CITY OF KIRKLAND
Planning and Building Department
123 Fifth Avenue, Kirkland, WA 98033
425.587.3600 ~ www.kirklandwa.gov

MEMORANDUM

To: Design Review Board
From: Kyle Cotchett, Associate Planner
Date: 1/23/23
File No.: DRV22-00693
Subject: **601 Market St Project**
DESIGN RESPONSE CONFERENCE

IDENTITY

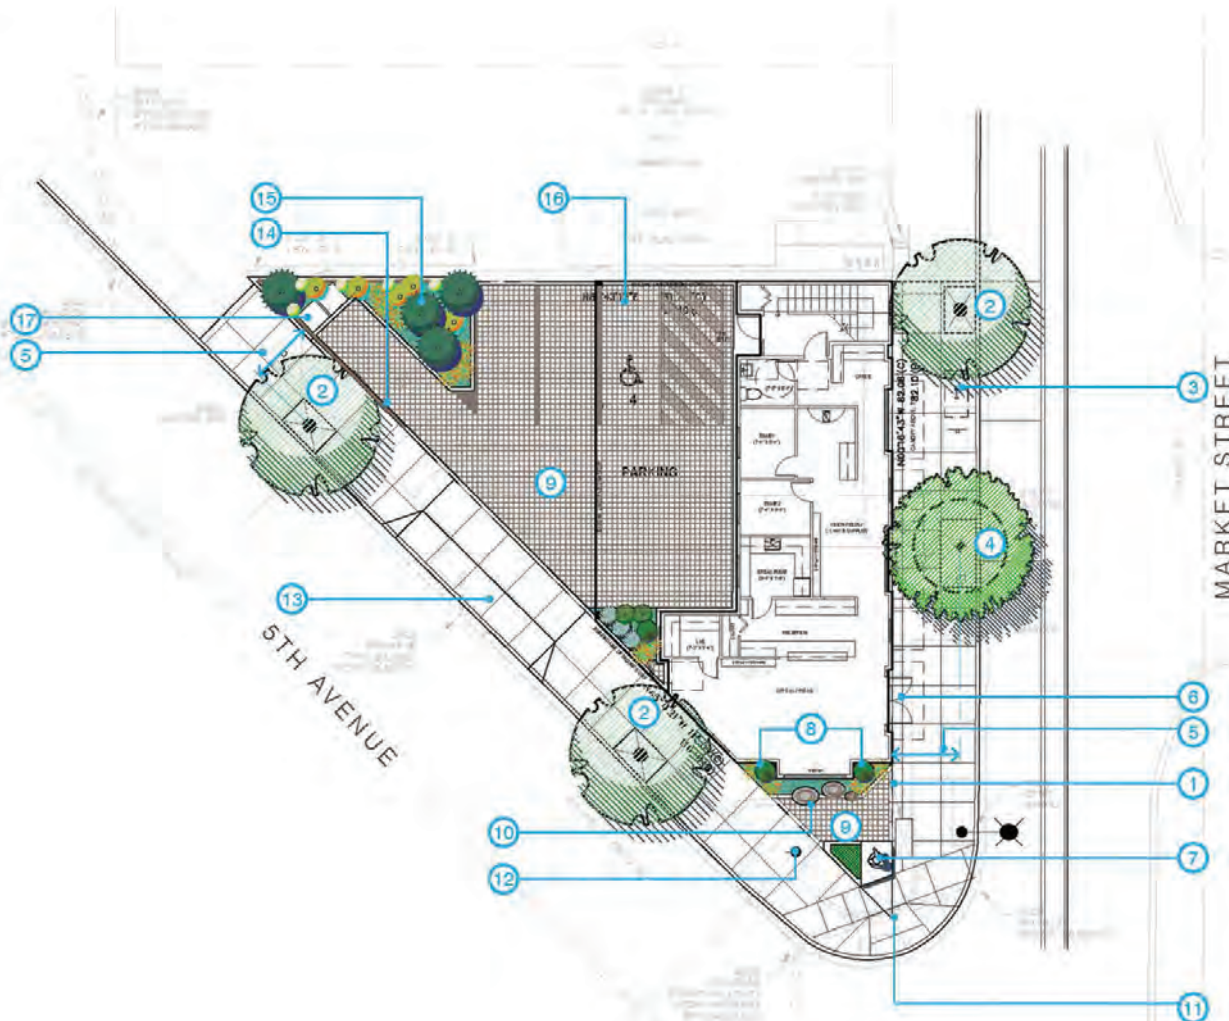
The applicant has called out certain buildings in their "Identity" sheet (see Attachment 2 page 4), which illustrates where they took inspiration from for their detailing and material usage. The use of brick on the façade comes from the materials used on the Sears, Campbell, and Kirkland Arts Center (Peter Kirk) buildings. The window treatment on the south corner bays and lap siding on the second floor mirrors the new residences on the other side of Market St and the neighboring retail building to the north, respectively. The roofline treatments have likewise been inspired by these buildings. The southern corner features a roofline detail like the new residential buildings, while the middle lap sided section of the second story features a similar plain roofline to the first story of the retail building to the north. The large display windows on the east façade reflect the Kirkland Arts Center.

LANDSCAPE PLAN

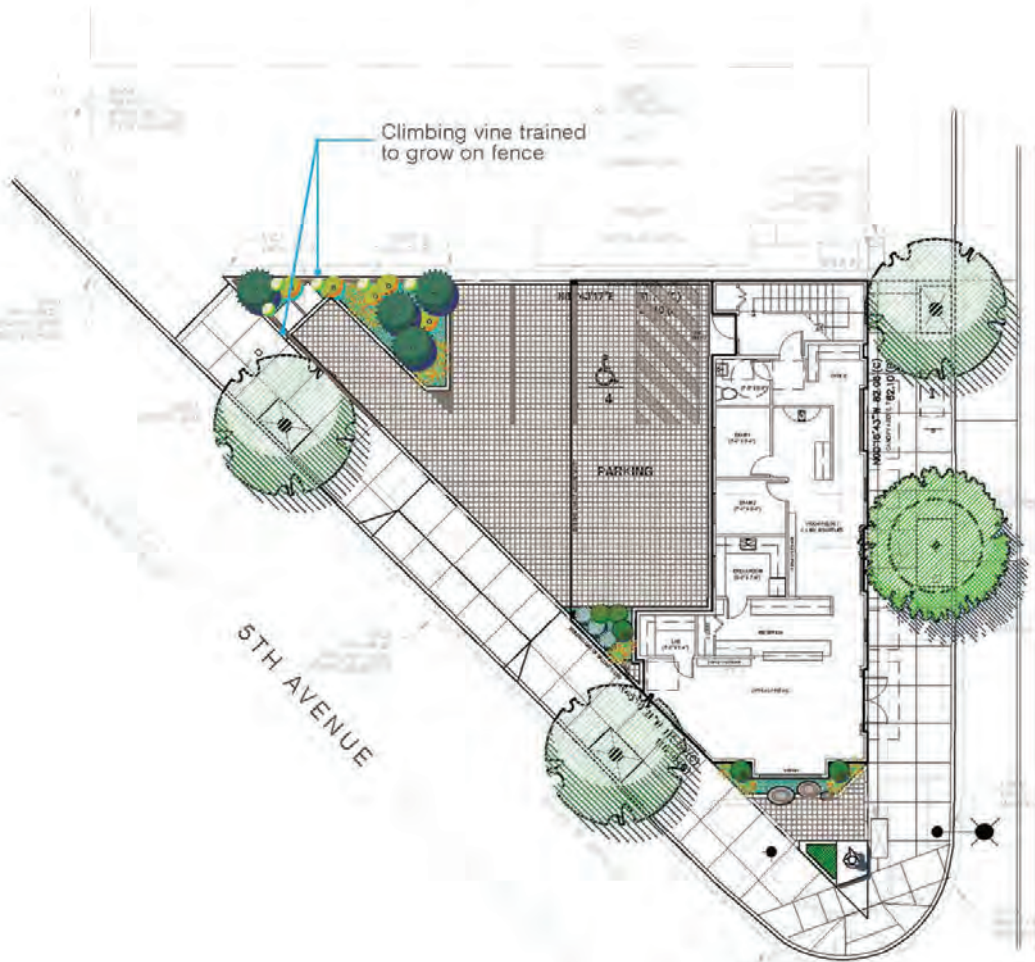
The applicant has submitted plans that give significant detail on the proposed “pocket plaza” including information on seating, pavement materials, landscaping, and artwork (see Attachment 2, pages 5, 6, and 25).

The applicant has proposed the pocket park to be located on the south corner of the subject property, which will abut both 5th Ave W and Market St. The “pocket plaza” will consist of two raised landscaped areas, seating, permeable paver walkway, and public art. The landscaping is proposed to be a mix of groundcovers, shrubs, and small trees. The applicant has proposed “stone egg” styled seating and to work with Troy Pillows Studio, which is local to the Seattle area, on the public art piece. The exact sculpture has not been designed at this time.

- Has the applicant provided adequate information regarding the design of the “pocket plaza”?
- Is more information needed on the design of the public art installation?
- Does the design of the “pocket plaza” successfully create a building front with a pedestrian-friendly feature?

The applicant has submitted a preliminary landscape plan for the "subject property and abutting right-of-way (see Attachment 2 pages 5 and 6). Landscaping should be placed in areas to help mitigate building massing and enhance the pedestrian experience along the project frontages.

- What changes (if any) are needed to the landscape plan?
- Are there other opportunities for landscaping?
